RAI 38: Description of Deficiency: The applicant did not provide the criteria used for determining the proposed locations for the airborne effluent monitoring stations.

RAI 38 Response (10/10/14):

Technical Report Marland Expansion Area

**FIGURE 2.9-2
LOCATION OF ENVIRONMENTAL AIR
SAMPLING STATIONS AT MARSLAND
EXPANSION AREA**

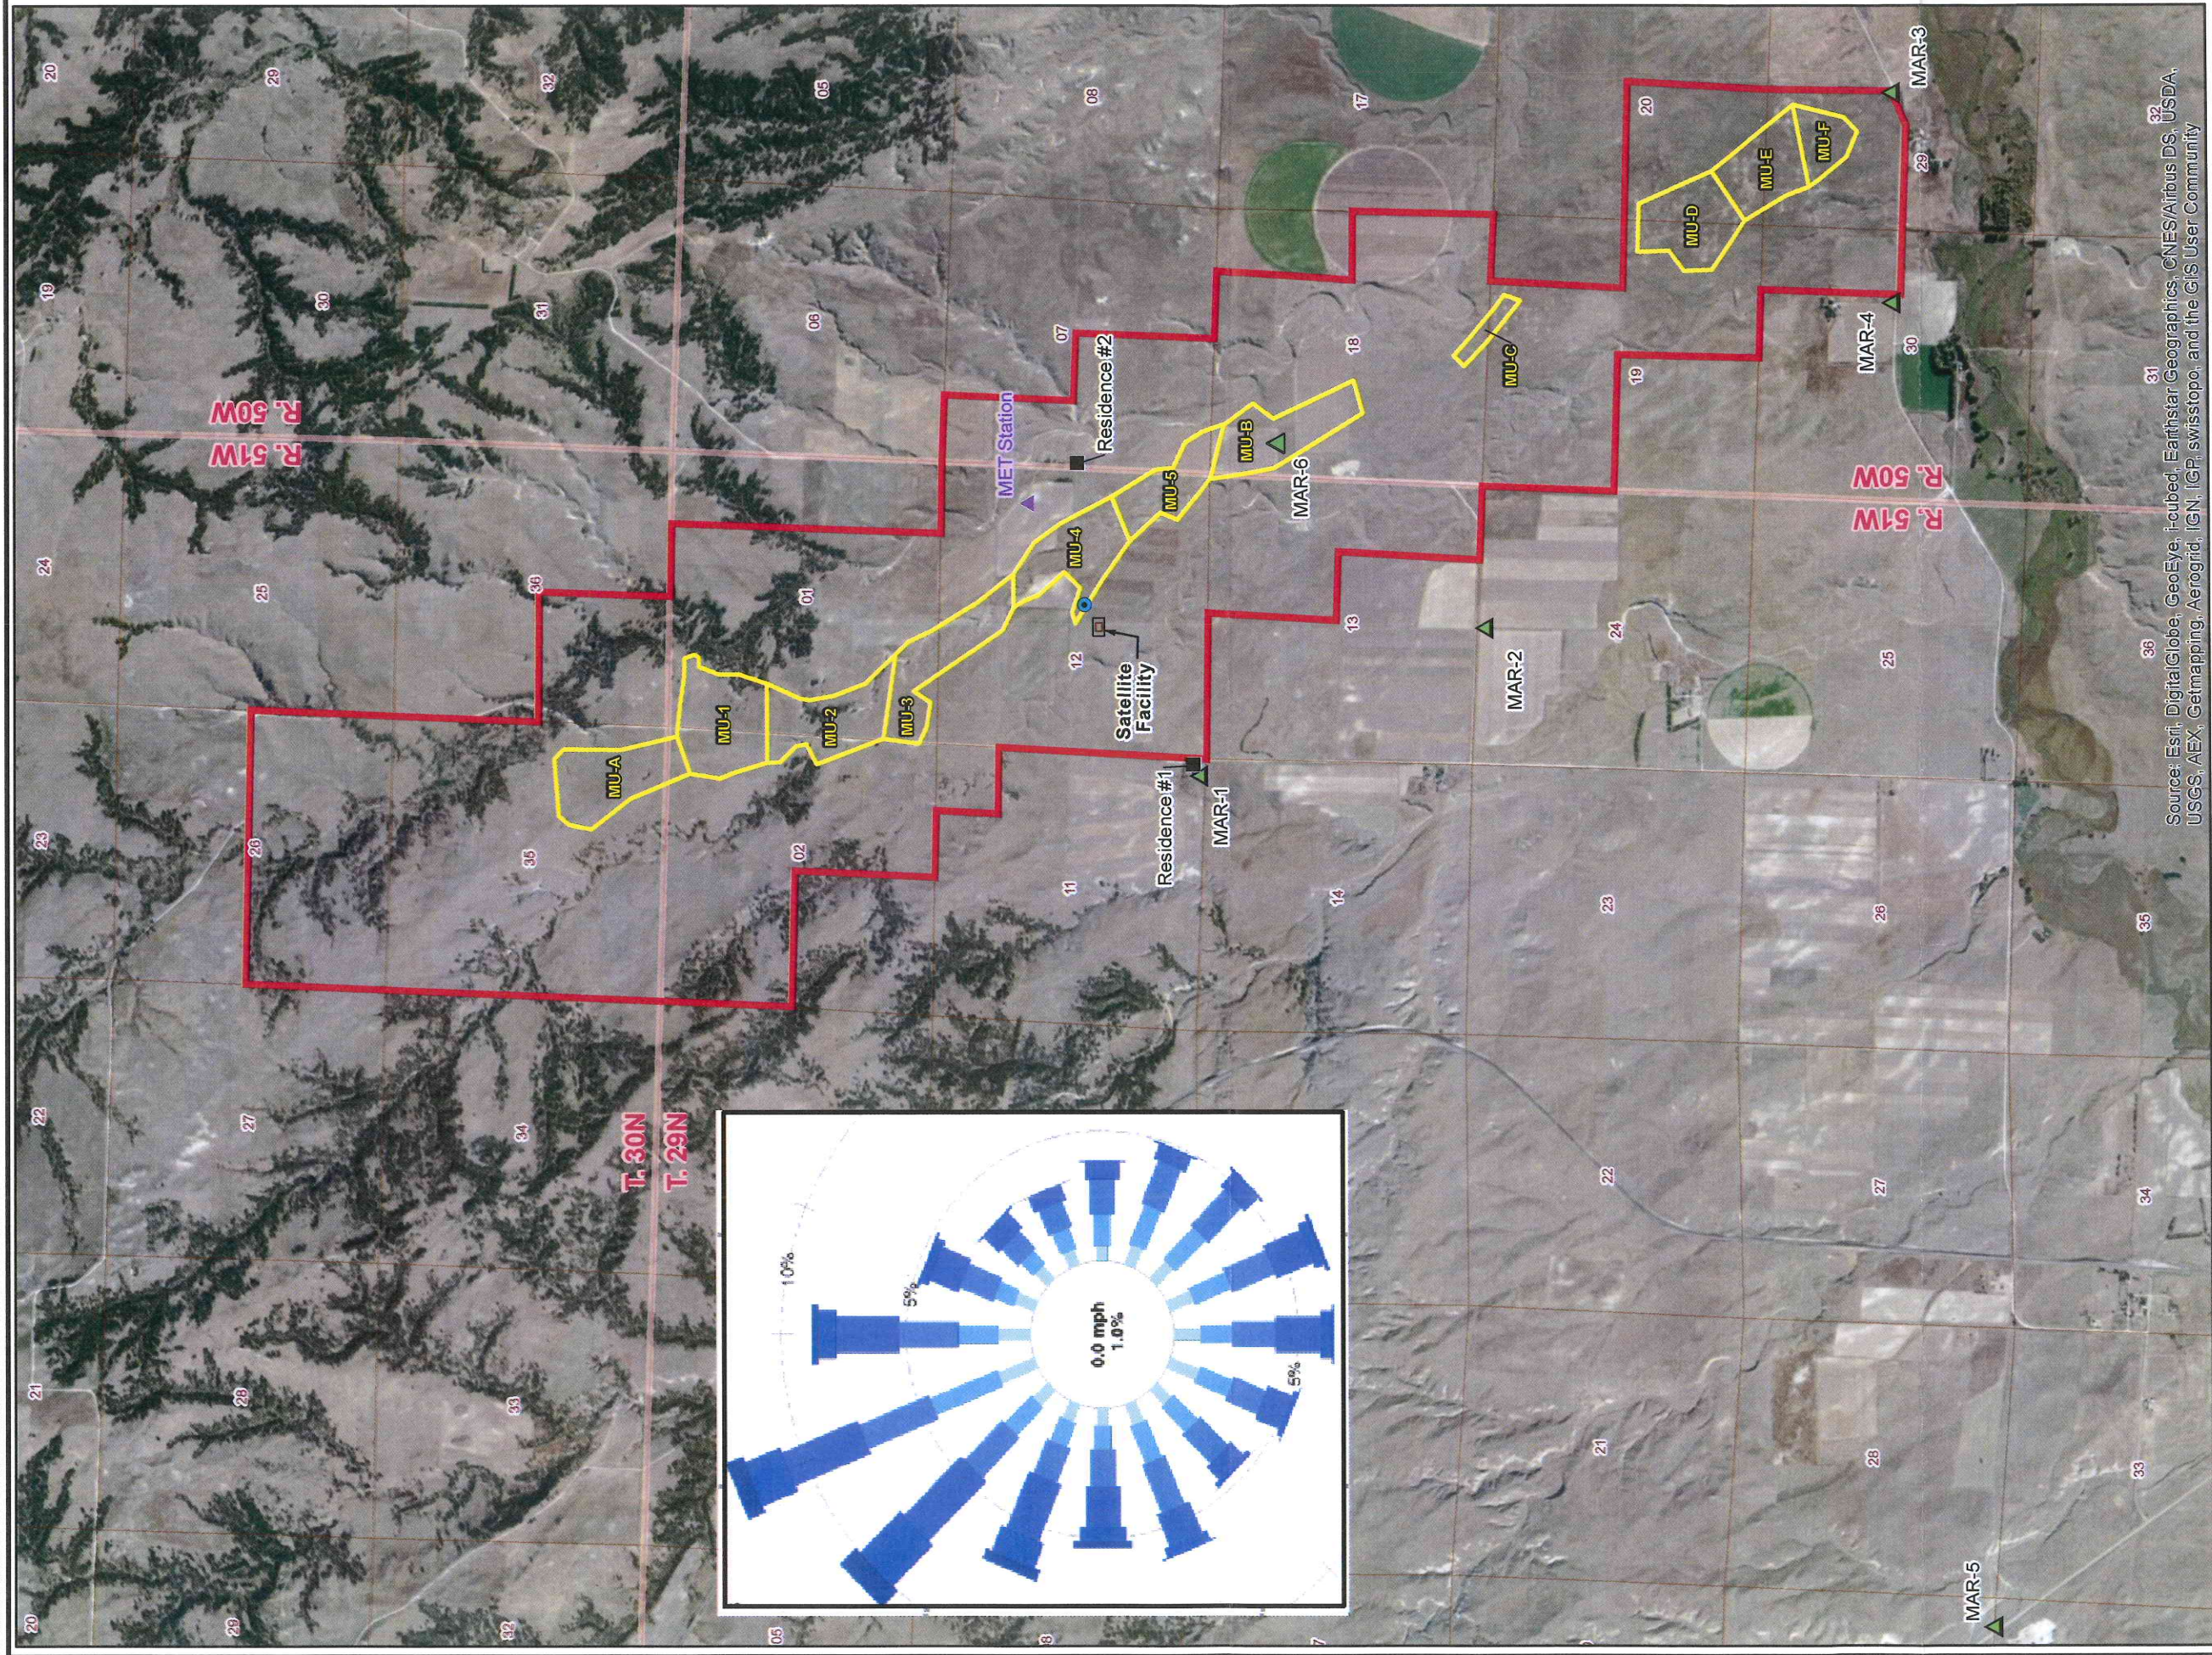
Request for Additional Information: Consistent with NUREG-1569, Acceptance Criterion 5.7.7.3(2), please provide the criteria used for determining the proposed locations for the airborne effluent monitoring stations.

Figures 2.9-2 and 7.3-2 have been revised accordingly.

In accordance with these criteria, **Figure 2.9-2** shows the locations of the five sampling stations (MAR-1, MAR-2, MAR-3, MAR-4, and MAR-5) ~~three sampling sites were located at~~ the project boundary (Sites MAR-1, MAR-3 and MAR-4 ~~and MAR-3~~). MAR-2, near the project boundary, was located directly south of the proposed mill. Due to landowner preference, MAR-2 was placed 2,891 ft. south and 1,371 ft. west of the permit boundary. ~~One of these (Site MAR-1) also coincides with the nearest, and most likely to be impacted, occupiable structure. A fifth~~ fourth sampling site (Site MAR-5) ~~was intended~~ selected to represent background conditions. Because the on-site wind rose indicates northeasterly winds to be the least frequent, this background monitoring site ~~was~~ is located southwest of the project boundary at a distance of approximately 4 miles (6.4 km). A summary of monitor locations and elevations for each of the monitors is shown in **Table 2.9-1**.
